## PLANNING COMMISSION STAFF REPORT

**SUBJECT:** Planning and Zoning Permit No. 06-400-5 (Coastal Development Permit) for Southern California Edison (SCE) Peaker Plant Located at 251 N. Harbor Boulevard

**Subject: Coastal Development Permit PZ 06-400-5, Proposed SCE Peaker Plant, 251 N. Harbor Blvd., Request for Additional Environmental Analysis for the Mitigated Negative Declaration**

L3  
 PRELIMINARY LANDSCAPE ELEVATIONS

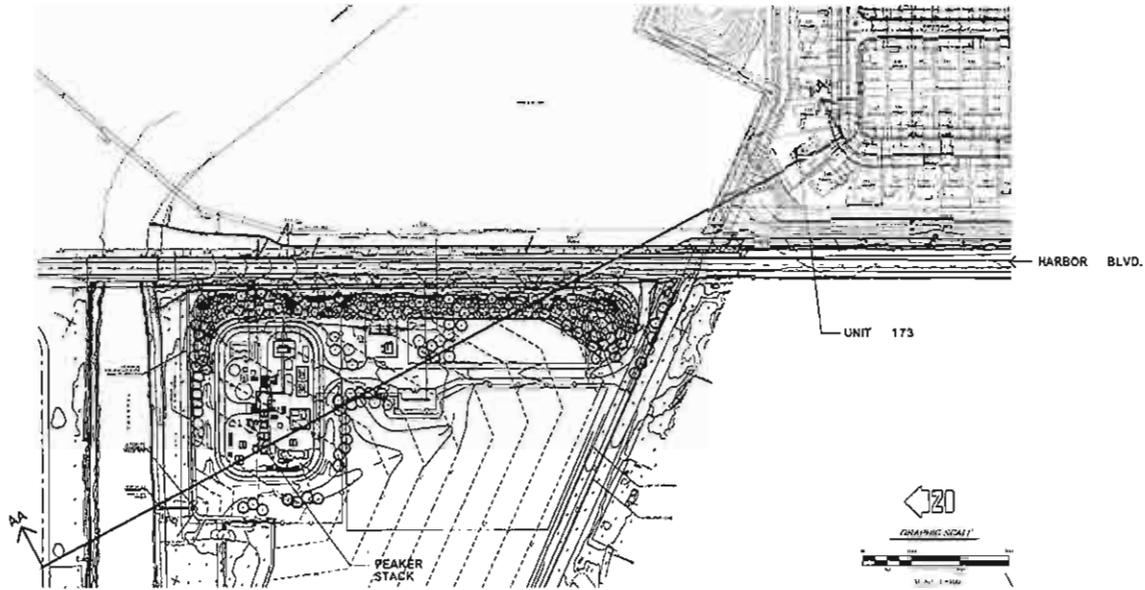
"The rationale for the new peaker stack having no significant adverse impact should not be that the new view is consistent with the existing view of the Mandalay power plant stack. The City considers the existing view as undesirable, and the MND seems to suggest that since there is already an undesirable view, adding to it is not significant. The explanation needs to be reworded to acknowledge that the existing view is unaesthetic and that the proposed new stack has a significant impact. As a view mitigation, SCE should reduce the height of the stack as much as feasible, consider painting the stack in a less obtrusive color, and/or landscape the substation facility on the east side of Harbor Blvd. in a similar manner as the peaker plant site. The photo-simulations of proposed landscaping should be shown in its initial planting, 2-3 years later, and at maturity."

Despite the fact that no mitigation is required, SCE concurs with the City that the project would add incrementally to the existing unaesthetic visual character of the site. This is why SCE has proposed to mitigate the impact of the proposed project to the extent

feasible by providing significant landscaping and has incorporated each of the City's suggestions into its proposed landscape plan.

Reducing the height of the stack is not feasible, and could result in additional undesirable impacts such as change in emission characteristics. The height of the stack has already been minimized to the maximum extent feasible and cannot be reduced further.

SCE's visual simulation specialist spent a great deal of time contacting nurseries in order to locate the proposed landscaping plants at the ages needed to comply with the City's request to create photo simulations at three different stages of growth, but was unsuccessful. In order to create the requested simulations, each plant in the plan must be photographed separately, masked out, & digitally planted in the location shown in the landscape plan in order to create the simulation. The native plants proposed as part of the landscaping plan are uncommon and were not easily available to be photographed at any stage of growth. In order to create the most realistic photo simulation possible of the mature planting, photos of plants with the same look and feel as the proposed plants were used to depict the majority of the native plants in the photosimulations. Actual photos were used for the ornamental trees and those natives that were available from an existing photo library. A mature plant cannot be scaled smaller to depict earlier stages of growth, since the visual appearance of the plant is different in each growth stage. Simulations of immature plantings are not typically done, so library photos are not available from which to select likenesses. Therefore, it was not possible to photographically simulate the earlier stages of growth.

Although it was not possible to provide a visual depiction of the first few years of growth following planting, the proposed landscape plan was designed to provide good shielding at all stages of growth. The plan contains plants in larger containers than are typically used for similar installations, utilizes dense plantings of plants with a variety of heights, incorporates a berm to improve site shielding in the early years, and includes plants expected to grow quickly and provide good coverage characteristics. This would provide coverage equal to or better than similar industrial facilities.

The revised landscape plan and visual simulations have been incorporated into the MND.

AA SECTION-ELEVATION THROUGH SITE FROM NEIGHBORING DEVELOPMENT  
SCALE 1"=40ft.

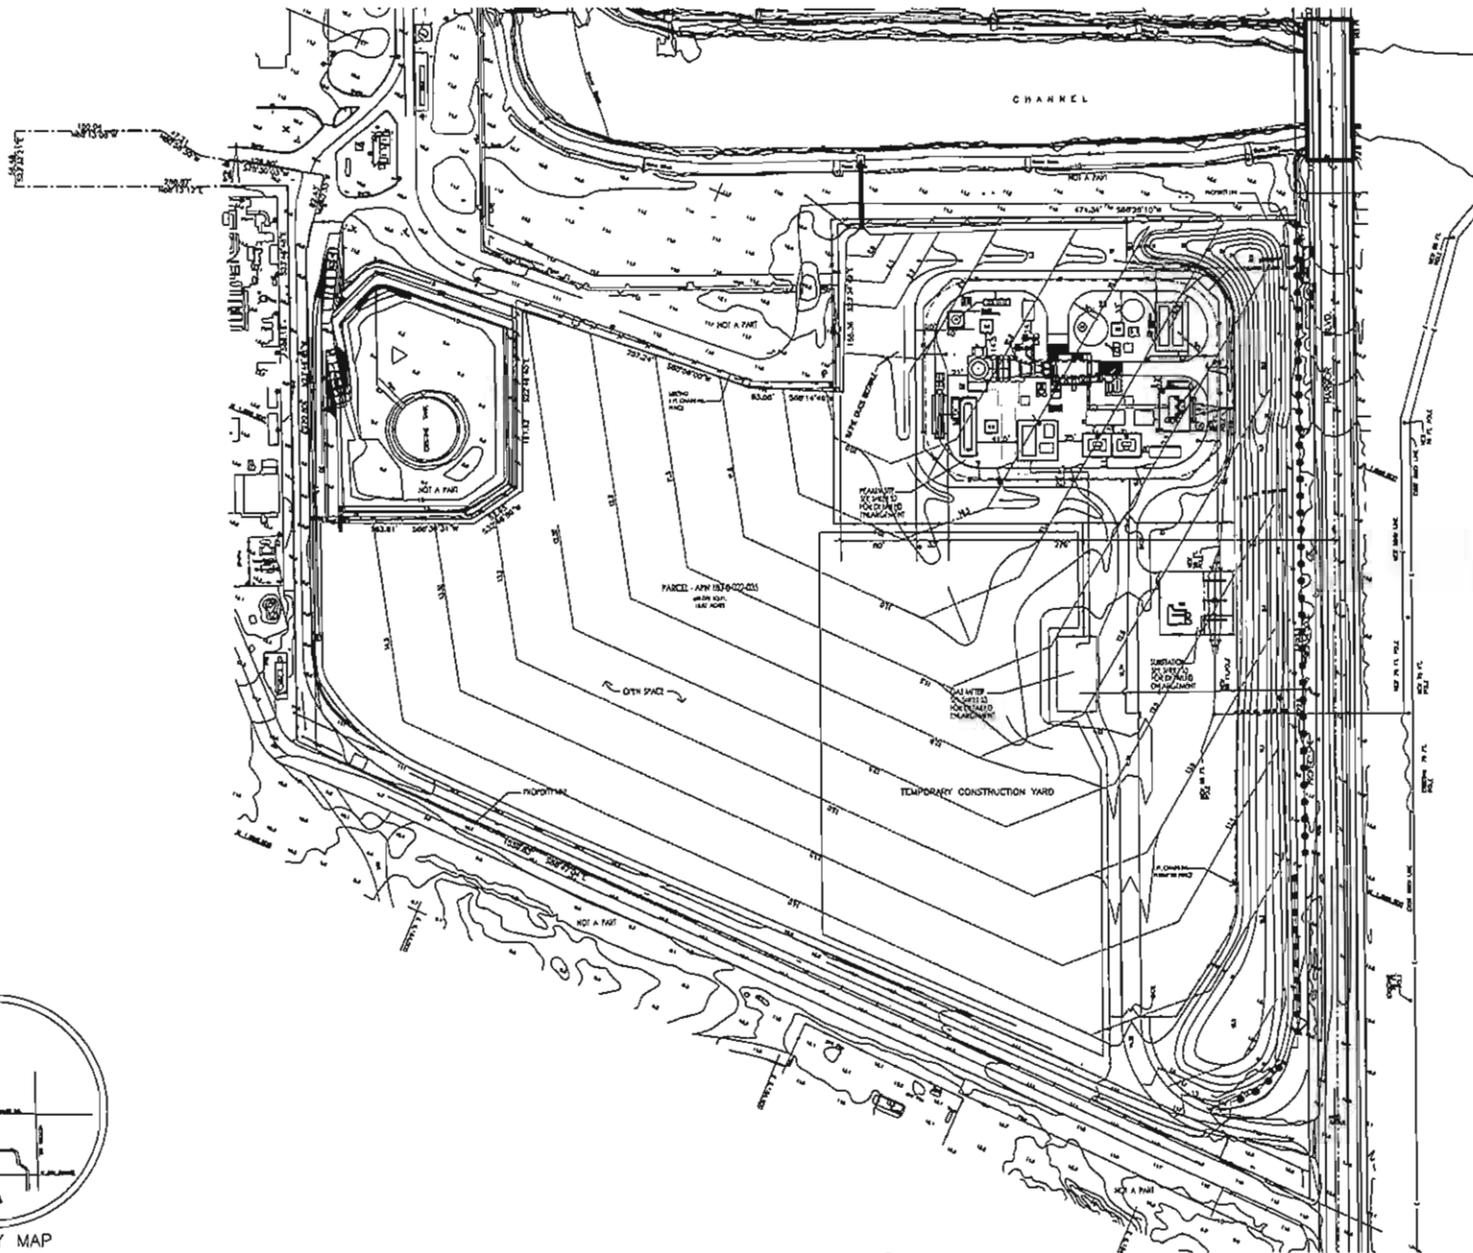
"The Northshore housing project, located just southeast of the project site, will have elevated building pads of up to 20 feet above Harbor Blvd. The MND needs to include an elevation cross-section from Northshore to the west lot line of the peaker plant to determine the line of site from the second floor windows of Northshore homes located opposite the peaker plant. Mitigations are needed to block the view from these windows. Northshore engineering, grading, and building plans are available from Linda Windsor, 805-385-7849."

Jordan, Gilbert & Brown reviewed information provided from both Linda Windsor and Bill Teller from the Northshore project regarding grading and building plans in order to prepare the requested elevation cross section from the second story window of the nearest home. In addition, SCE created a computer simulation of the view from this home. Both views show that the tree species used in the proposed landscape plan will, at full maturity, fully shield the facility from the Northshore development's second story windows as requested, with the exception of the stack and the transmission poles which are not able to be shielded. We expect that within 3-5 years after planting, the growth rate would be such that the majority of the facility would be fully screened.

The requested views have been incorporated into the MND.
